Welch Allyn, Inc. 4341 State Street Road Skaneateles Falls, NY 13153 USA	URGENT: Field Safety Notice	2021-07-001-MKE-005
---	------------------------------------	---------------------

ELI280, MLBUR280 and BUR280 Electrocardiographs

ELI280 resting electrocardiograph - Patient mismatch/Software Upgrade

Type of action: **Software Upgrade**

Figure.1

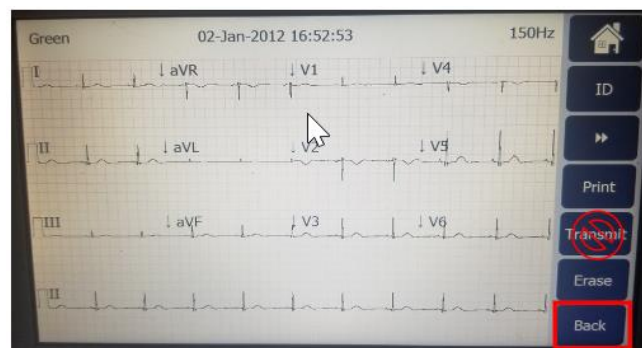
1. An ECG is acquired for Patient A and stored to the cardiograph.
2. An ECG is acquired for Patient B and stored to the cardiograph.
3. The ECG record associated with Patient A is retrieved from memory and any Patient Demographic information is edited.
4. After editing, the "Resting ECG" screen is presented as shown below. Figure 1
5. Pressing the TRANSMIT button from this screen (following any Patient Demographic edit) will transmit an ECG record other than for patient A. (see figure 2, which shows the Resting ECG screen).

If an ECG record is retrieved from the patient directory for a Patient Demographic edit to be performed, once the information has been edited and the screen above (Fig 1) is presented, do not press the transmit button. Instead, press the BACK button which will SAVE the changes to memory and present the user with the following screen, where the SYNC button can be used to transmit the desired record to the configured destination.

Figure.3

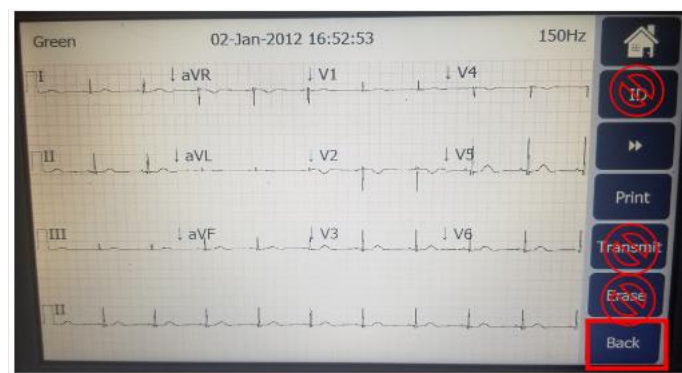
1. An ECG is acquired for Patient A and stored to the cardiograph.
2. An ECG is acquired for Patient B and stored to the cardiograph.
3. The ECG record associated with Patient A is retrieved from memory and ID information is edited.
4. After editing, the “Resting ECG” screen is presented as shown in Figure 3.
5. The user decides to make another ID Edit without leaving the “Resting ECG” screen and presses the “ID” button - Figure 3.

6. After the second edit is performed, the “Resting ECG” screen is once again presented as shown above.
7. Pressing the TRANSMIT button from this screen (following two ID edits in a row as defined above) will transmit an ECG record with the patient demographics
